Rezoning Application: PD 24-0924

Development Services Department

PETITION NO: PD 24-0924

RE: Dixon Drive PD Rezoning (PD 24-0924)
Folio: 77656-0000, 77657-0100
Administrative Variance Request – Dixon Drive
Palm Traffic Project No. T24026

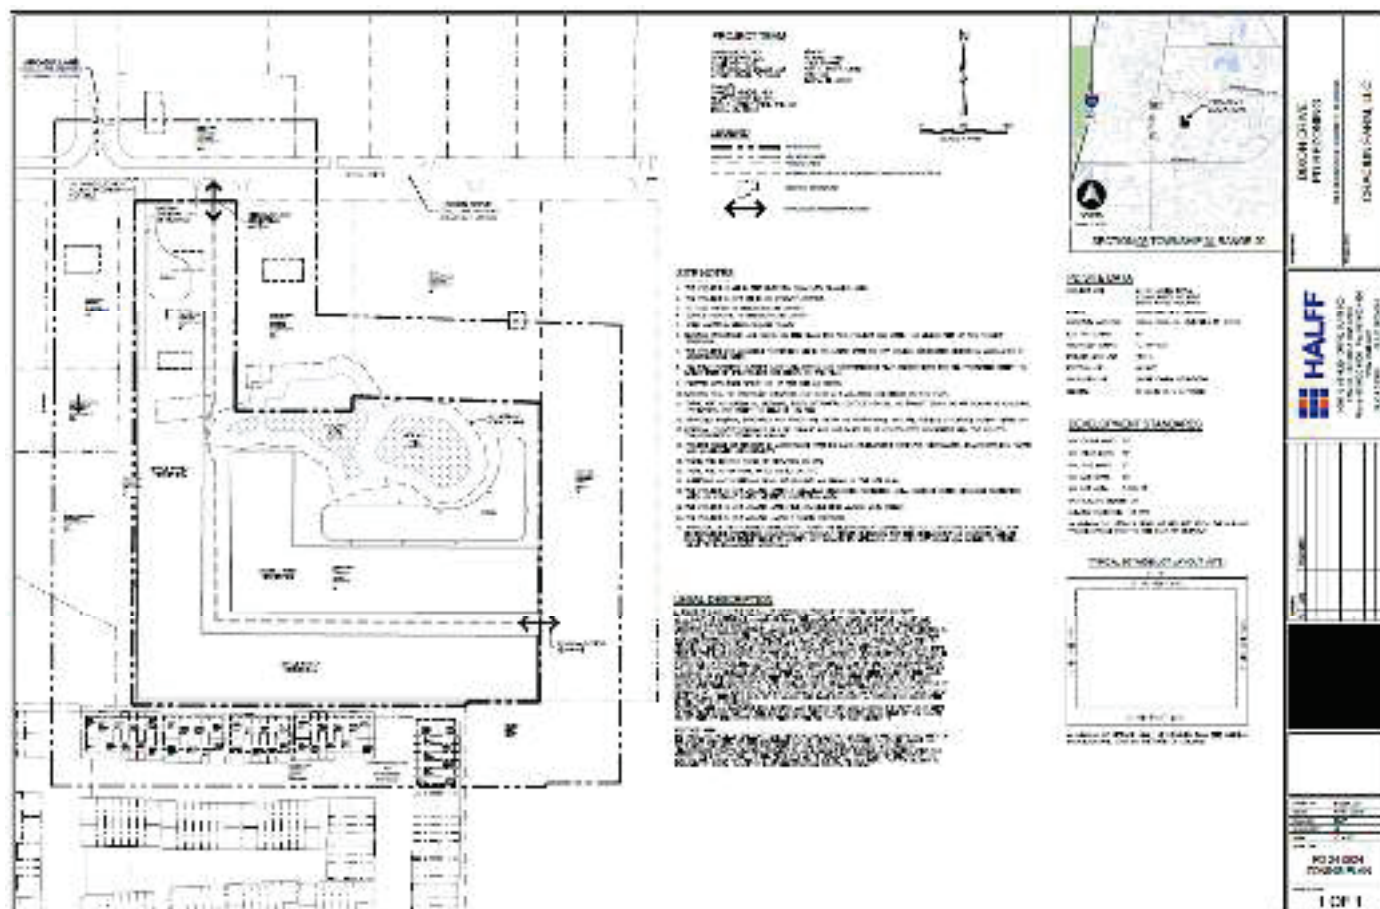
1. The rear yard setback shall be changed from 10' to 20', under the Development Standards on the site plan.

DRAWING NO. **TS-7**

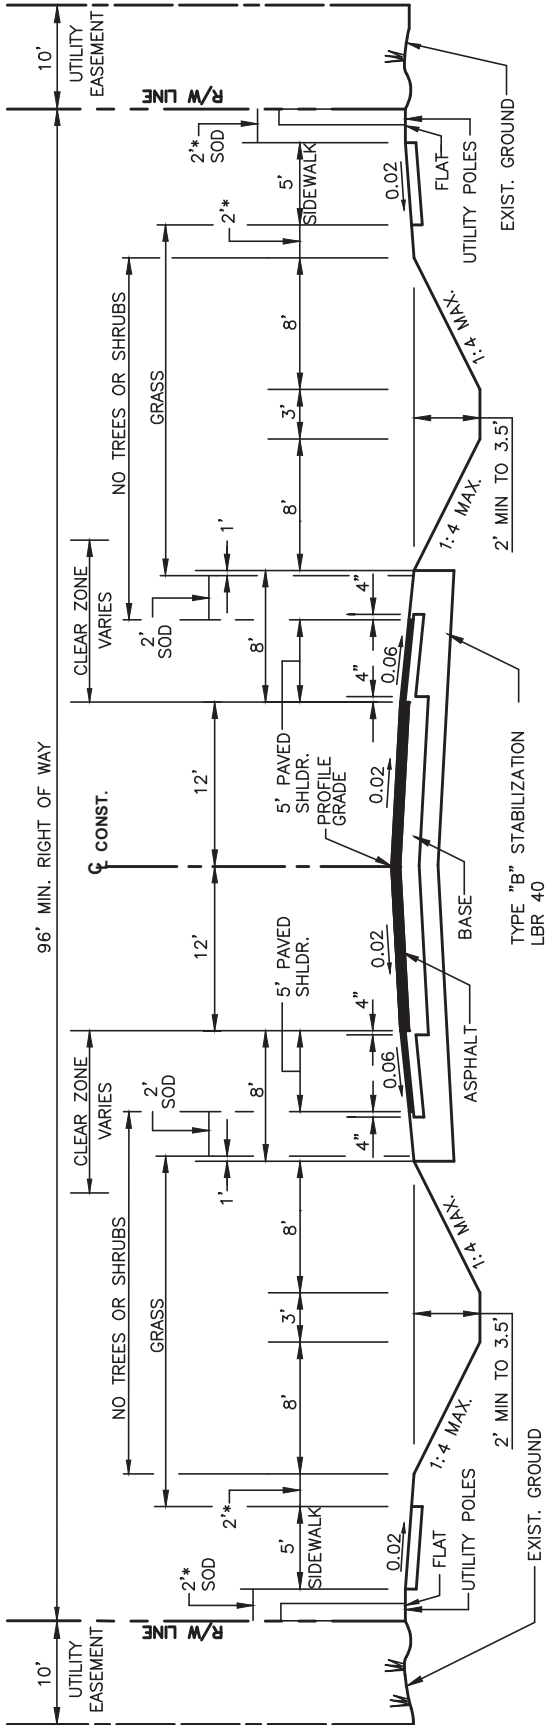
This request is for an administrative variance to the TS-7 typical section of the Hillsborough County Transportation Technical Manual in accordance with LDC Section 6.04.02.B for the section of Dixon Drive from US 301 to the project driveway, for the following reasons: (a) there is an unreasonable burden on the applicant; (b) the variance would not be detrimental to the public health, safety and welfare; and; if applicable, (c) without the variance, reasonable access cannot be provided. These items are further discussed below.

The existing ROW along Dixon Drive is approximately 80 feet. The typical TS-7 section for local and collector rural roadway requires a minimum of 96 feet of ROW with 12-foot travel lanes, a 5-foot paved shoulder, open drainage and a 5-foot sidewalk. The adjacent segment of Dixon Drive has approximately 10-foot travel and open drainage on both the north and south sides and no sidewalks along the roadway. This segment of Dixon Drive was recently repaved by Hillsborough County. Due to the constrained right of way on Dixon Drive, the additional travel lane width and sidewalk cannot be provided. Therefore, the requirement to improve Dixon Drive is unreasonable.

I have found the attached Section 6.04.02.B. Administrative Variance (AV) for PD 24 -0924 APPROVABLE.
